Teewood Farm Barn
Waddington

Proposed Roof Plan

DRAWING NO.	REV
046_PLN_203	C

1 Scale: 1:50
Proposed Roof Plan

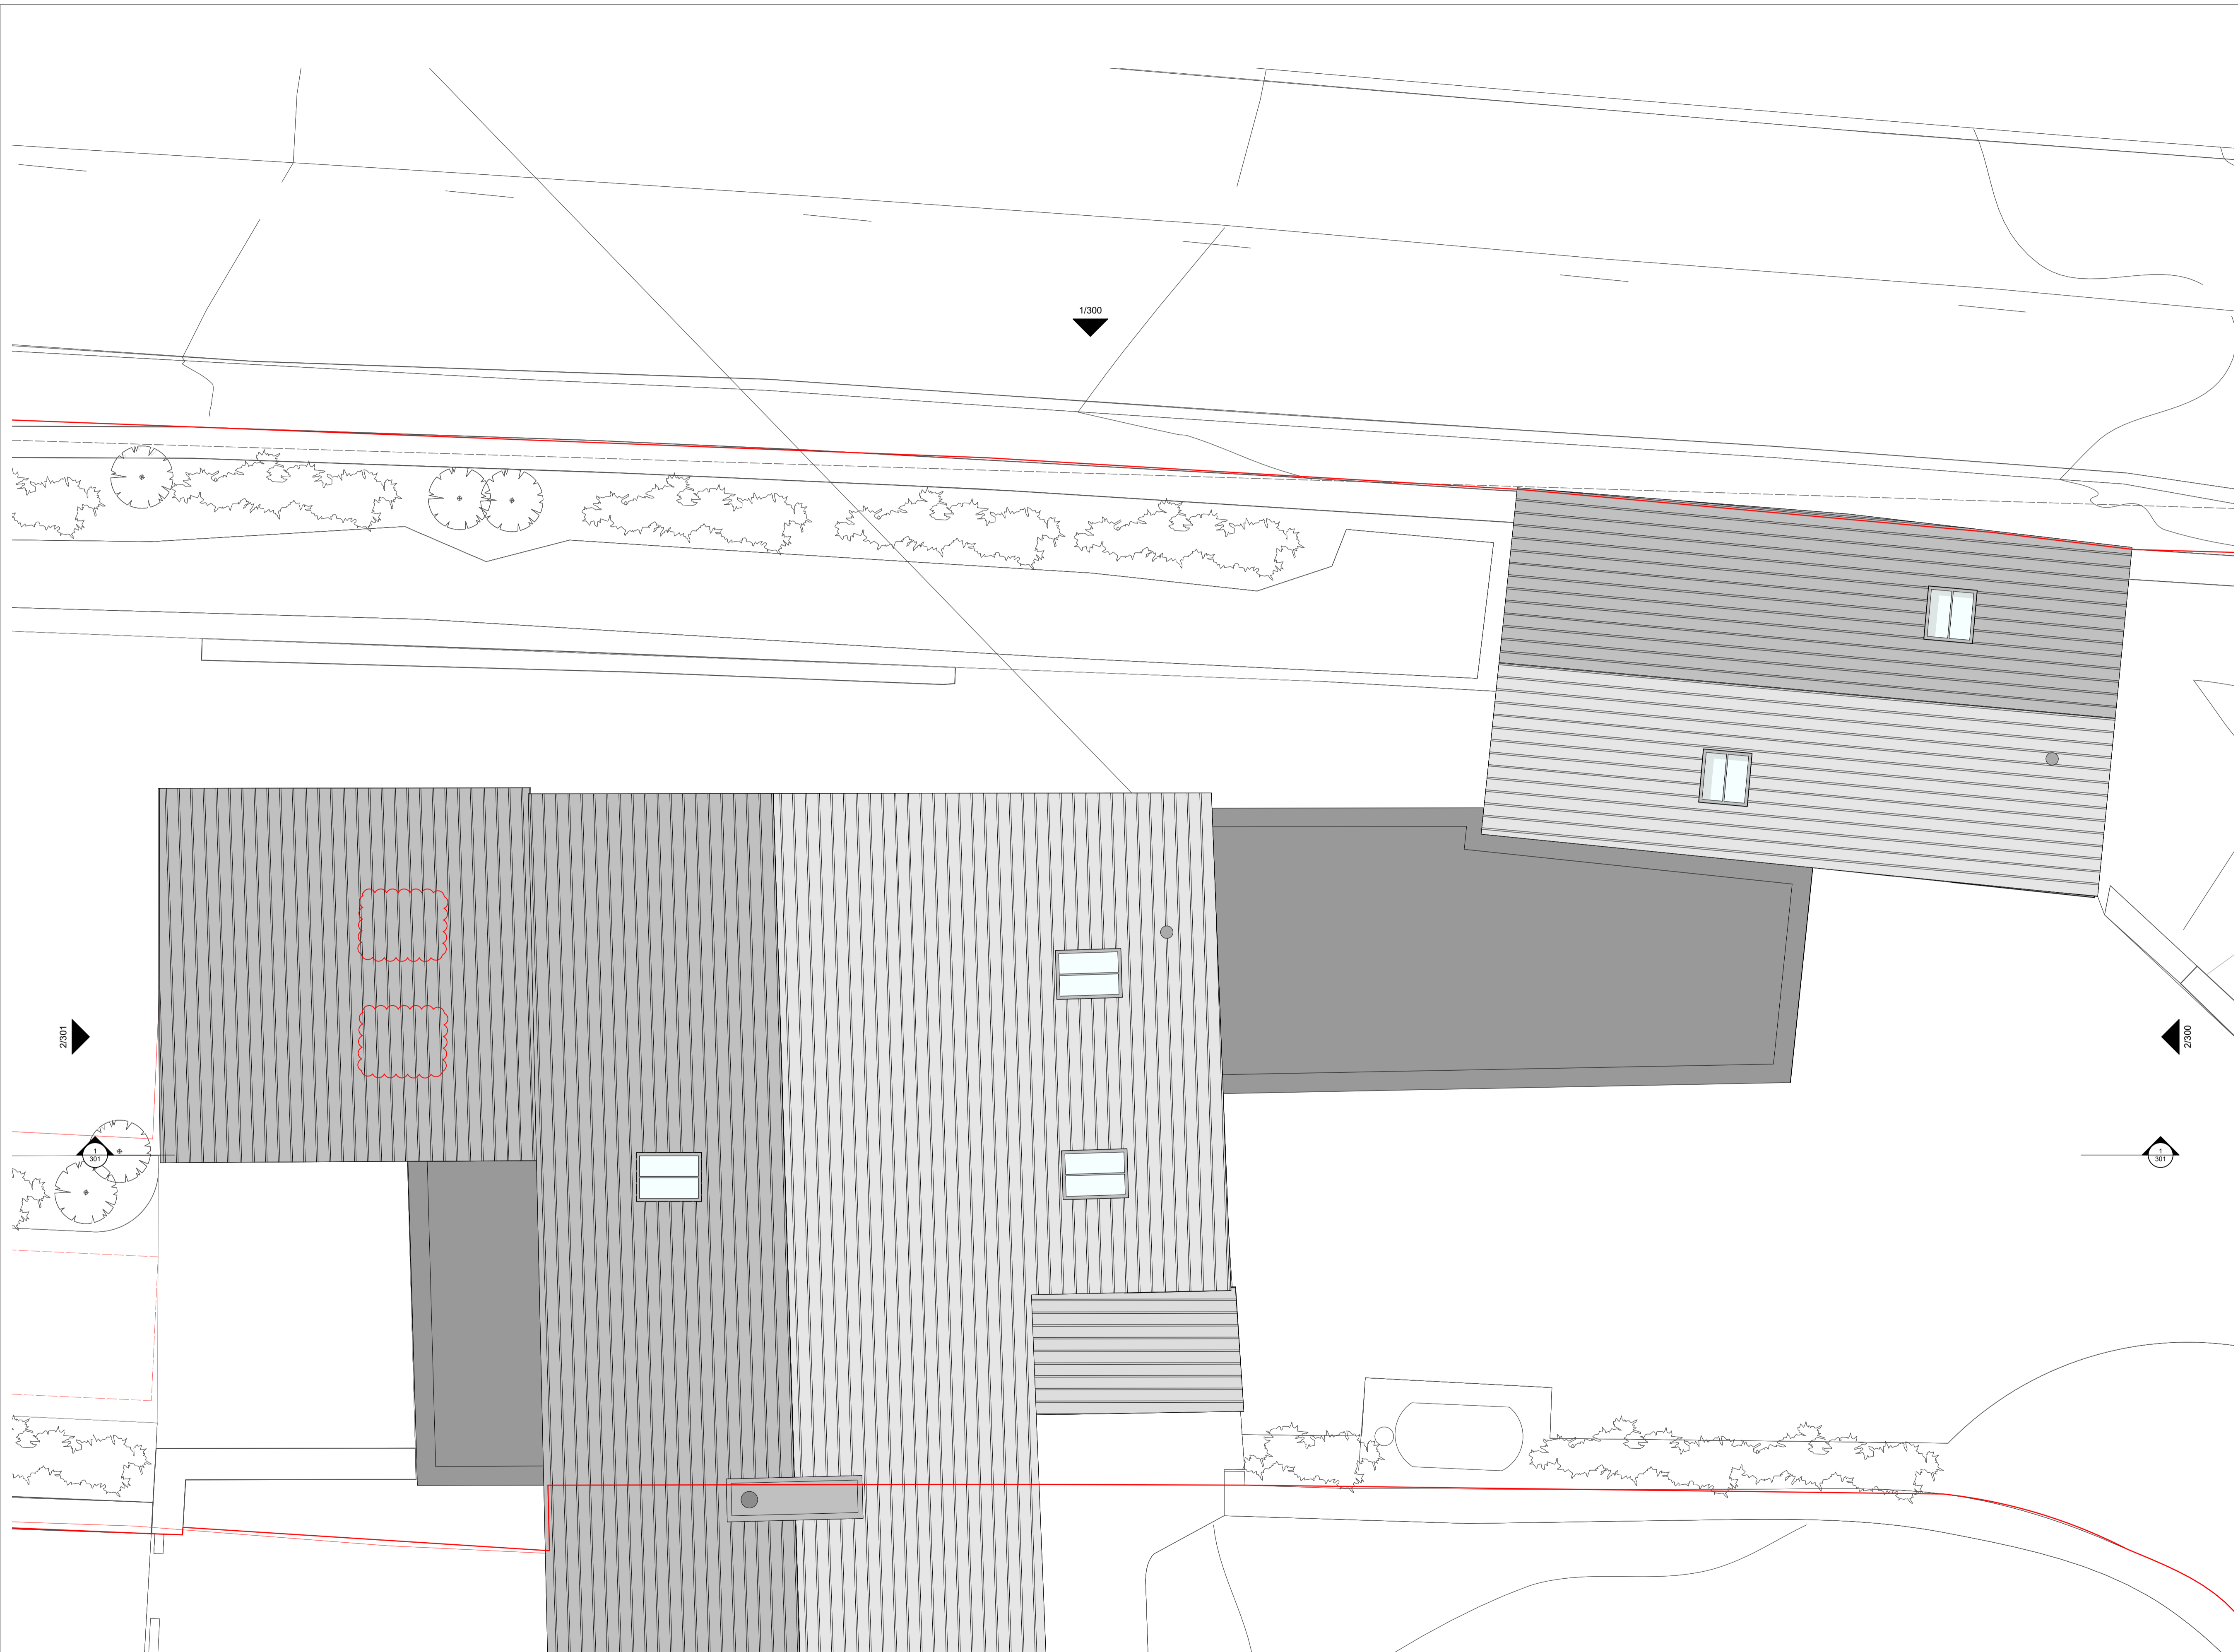
REV	DATE	NOTES
A	16/08/2022	ISSUED FOR PLANNING
B	25/05/2023	ROOFLIGHT OMITTED AND BIKE STORE SHOWN AS EXISTING IN RESPONSE TO LBC COMMENTS.
C	05/06/2023	2 NO. ROOFLIGHTS OMITTED IN RESPONSE TO LBC COMMENTS.
